**Case #:** HPC 2018.075  
**Date:** June 2, 2018

**PRESERVATION STAFF REPORT**

**Site:** 34 Spring Street, #4

**Petition:** Hatice Baser, Trustee, seeks permission from the Somerville Historic Preservation Commission (HPC) to reconstruct the deck on the rear ell of the building.

Original roof deck.

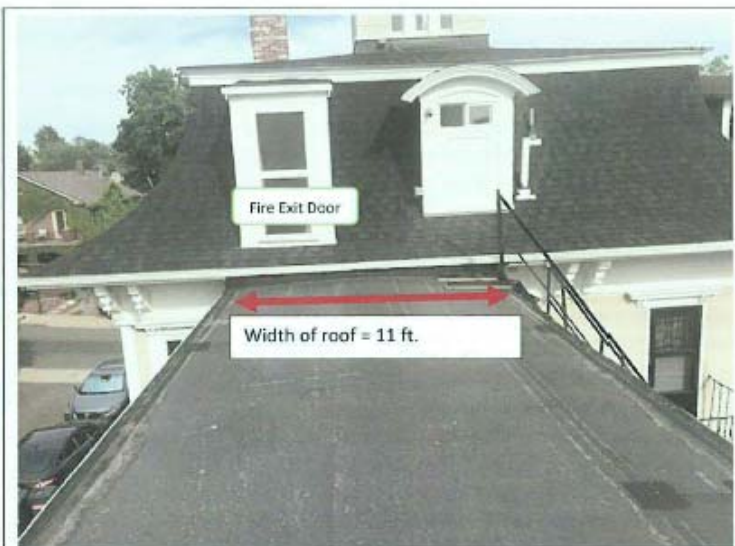
The original deck had a lattice enclosure, This will not be replaced. The railings and balusters will be the simple generic type that the Commission has approved in the past.

**Staff Findings:** Staff finds that the proposed roof deck and egress will be located on the flat-roofed rear ell. It will be visible along the driveway from the right side of the house and have no effect on the roof structures. Staff finds that it does not significantly detract from the historic character of the house and to some extent is necessary for the safety of the occupants.

1. All appropriate building permits shall be obtained prior to the start of any work.
2. If changes are necessary to the proposed design for which this Certificate of Appropriateness was issued, new plans shall be submitted to Historic Staff prior to commencing the work.
3. The deck shall have simple rails, balusters and posts with a shallow decorative top to meet code height and painted to match the building trim.
4. Historic Staff shall issue a sign-off upon completion of the project that this was done in accordance with the Certificate and approved plans.
